# PUBLIC CONSULTATION SUBMISSION TO ABP

Shannon Homes, strategic housing development on a site at  
Taylors Lane and Edmondstown Road, Ballyboden, Dublin 16

Case Number: 307222

Extract from the MMP illustrating cycling off-site linkages but not how cycling to/from the development interacts/accesses them

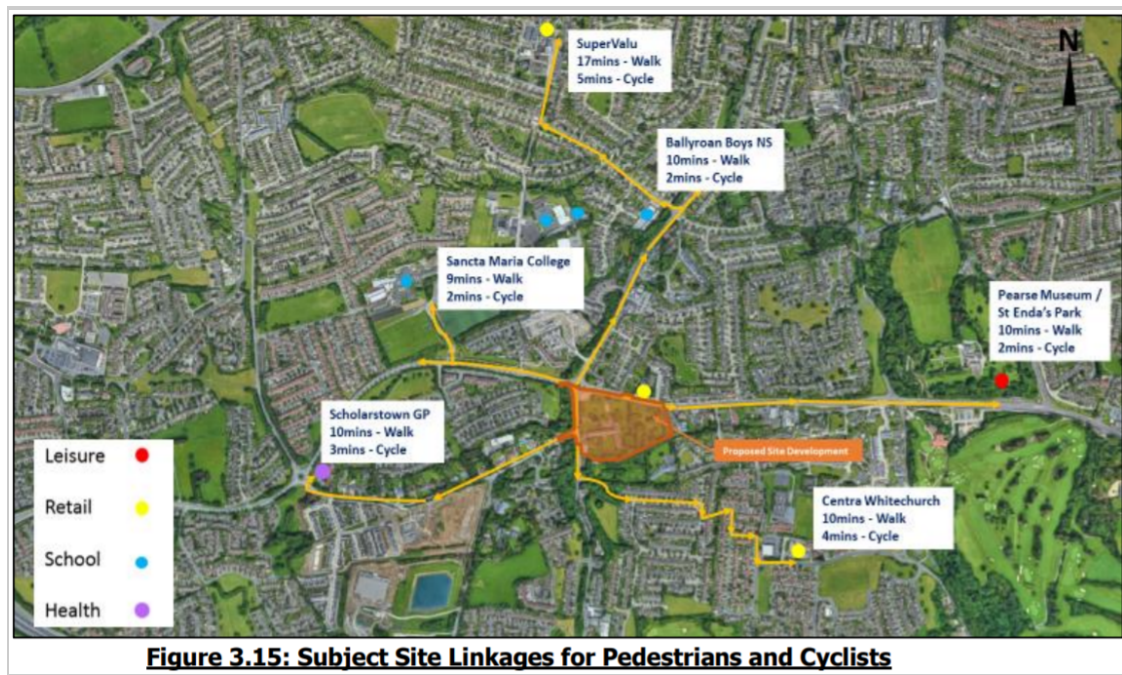
The Mobility Management Plan (MMP) states (A1.21) that *“the on-site cycle facilities will be linked to the existing off-site cycle routes”*. On-site cycle facilities are not fully linked to the off-site cycle routes.

Extract from the Traffic & Transport Assessment Report showing the RSA Collision Records in the vicinity of the development

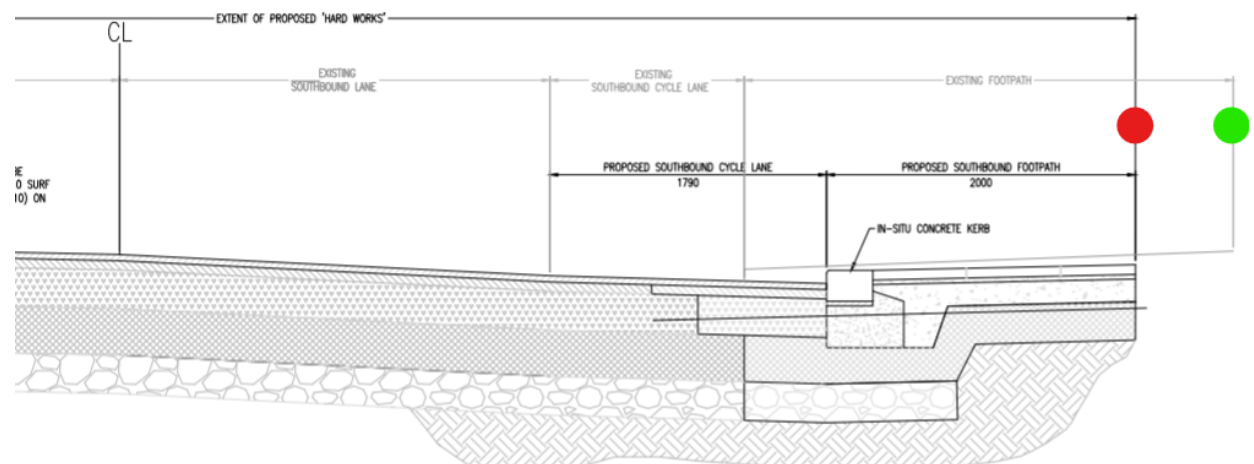
TTA Section 2.5.4 states the *“review of the RSA data available reveals that there are no apparent trends in collisions which have occurred in the vicinity of the subject site during the most recent 11-year period (2006-2016)”*. However, a cursory review of the provided collision data indicates a clear trend - 12 of the 14 collisions were in the near vicinity of junctions and signalised crossings around the development. Briefly:

- 1, 3: pedestrians crossings
- 2: roadside parking at the location of the proposed cycling access
- 4, 5: T-junction
- 6-11: roundabout
- 12, 13: signalised junction
- 14: existing car park entrance

This emphasises the need for high quality design of the public road works to ensure cyclist safety and comfort.

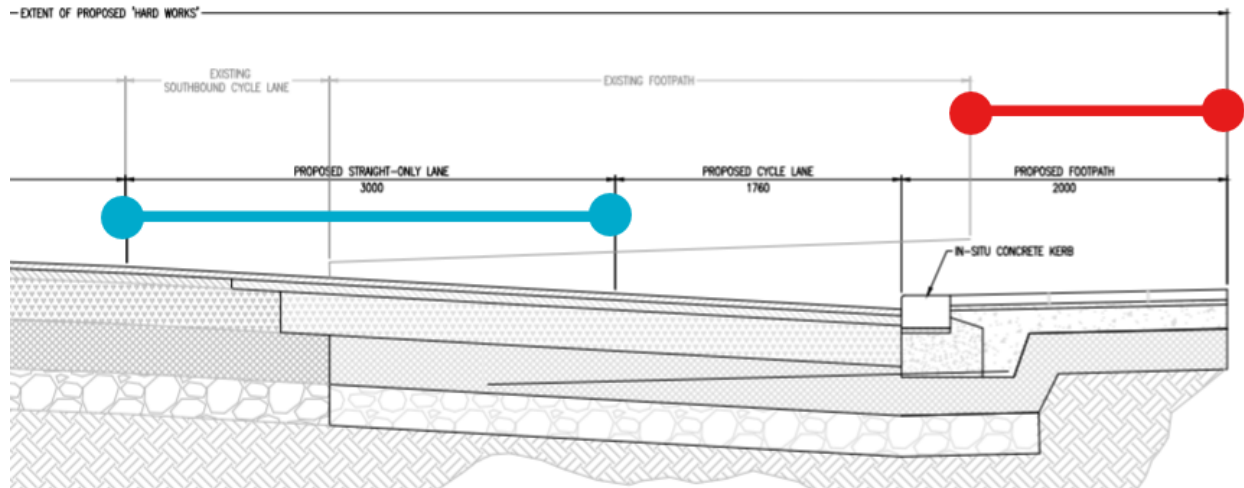
3. Along the section of road where the new general traffic turning lane is added, the corresponding space for this lane is not being provided by the development - refer to the figure below. The net result is that the public road corridor width available for improved cycle infrastructure is reduced. The existing road cross section of ~14m width would have allowed the upgrade to 2m wide cycle tracks (required as a minimum in the NCM

for this road), however the proposed development works would hinder this allocation of space to cycling.

Extract from NCM 4.4.2 showing a typical 4 arm junction with ASLs

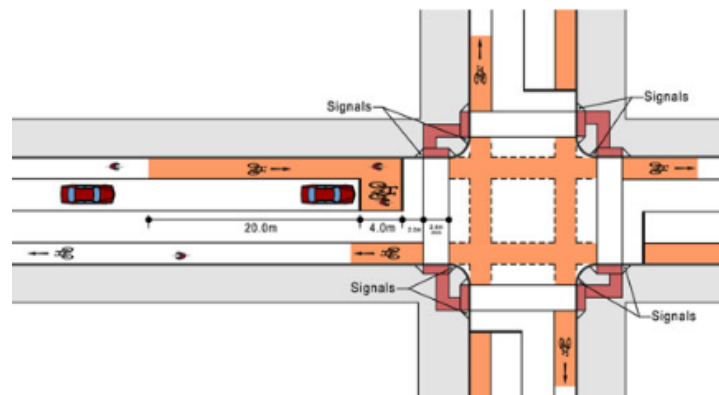
4. No Advanced Stacking Locations (ASL) are provided at the Scholarstown Rd Junction. ASLs are specified in Section 4.4.2 of the NCM. They facilitate stacking of higher volumes of straight ahead cycle movements, and also to accommodate right-turning cycle movements.

Extract from the NCM Section 6.4 showing a typical cycle track cross-section

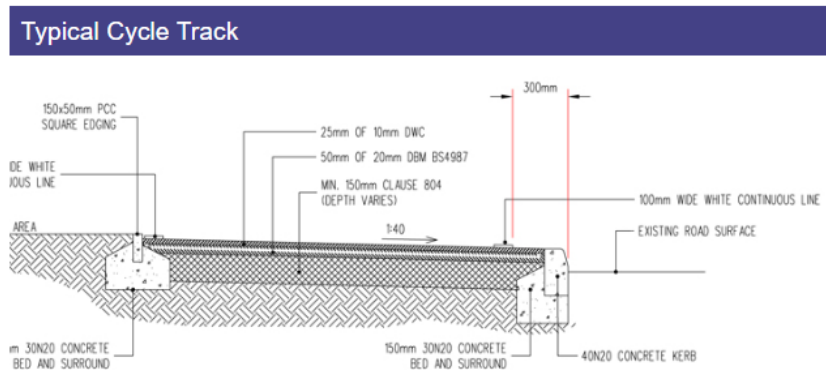
route, the cycle tracks should be designed to a similar standard and agreed with SDCC and the NTA.

Point 6: Extract from drawing *Roads Layout for Cross-sections*, with the blue X marking where southbound vehicles will be directed into the cycle track due to the poor junction design

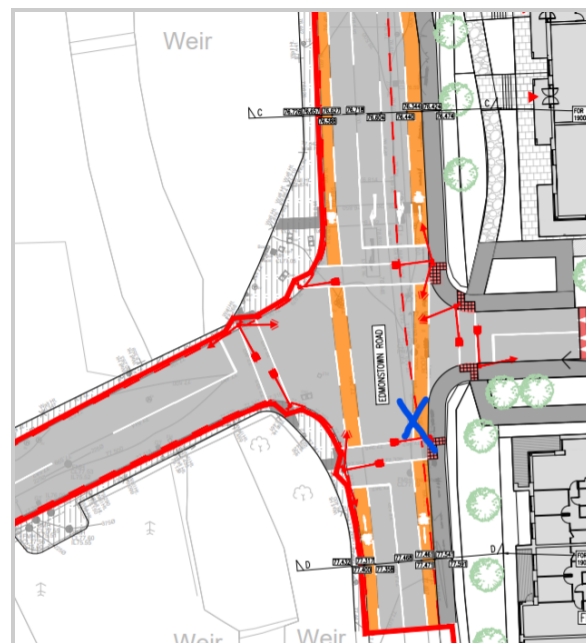
6. The design of Scholarstown Junction results in a dangerous layout for cyclists travelling south toward Edmondstown. Motor vehicles travelling straight through the junctions will be directed toward the cycle track at the exit of the junction (marked in the figure below). The junction design is not in compliance with the principles outlined in Section 4 of the NCM. Further land could be provided by the development on the south of the junction to rectify the issue.

Extract from drawing *Roads Layout - Ground Floor* showing the cycle entrance onto Taylor's Lane. Red dots: parallel parking, Yellow dot: existing pedestrian crossing

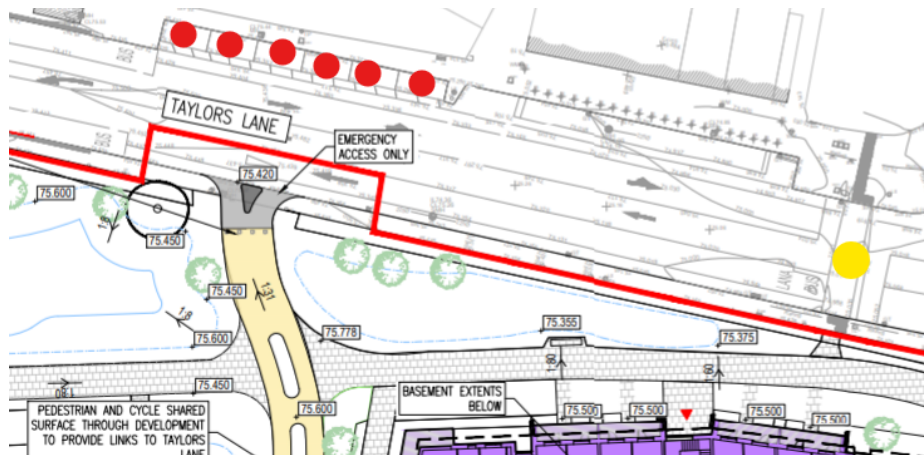
We note that the map provided in the Planning Report indicates the Taylor's Lane cycle lane is segregated from the road (refer to figure below). This is incorrect, the lanes should be designated C2.

The Architect's plan drawing calls the entrances at the pedestrian crossings "pedestrian access", while the Engineer's drawing *Roads Layout - Ground Floor* indicates the paths linking to the entrances are "pedestrian and vehicle", with the pedestrian/cyclist path specifically designated as leading to the emergency vehicle access. This access is located between the two pedestrian crossings. There is not a safe crossing specified for cyclists to utilise the emergency vehicle access. For example, exiting the development and turning east on Taylor's Lane, people cycling will have to cross a footpath, cycle lane, bus lane, two general lanes and then contend with vehicles exiting/entering the parallel parking spaces on the north side of the road. The access is also positioned directly beside a bus stop, so anyone using the access could be obscured by a stationary double decker bus, and potentially another bus queueing behind it.

Provision should be made for people cycling to access and use the development pathways leading to the existing pedestrian crossings (with the crossing upgraded to toucan crossings) or a new controlled crossing should be installed for cyclists at the emergency vehicle access. Consideration needs to be given to relocating the bus stop away from the emergency vehicle access.
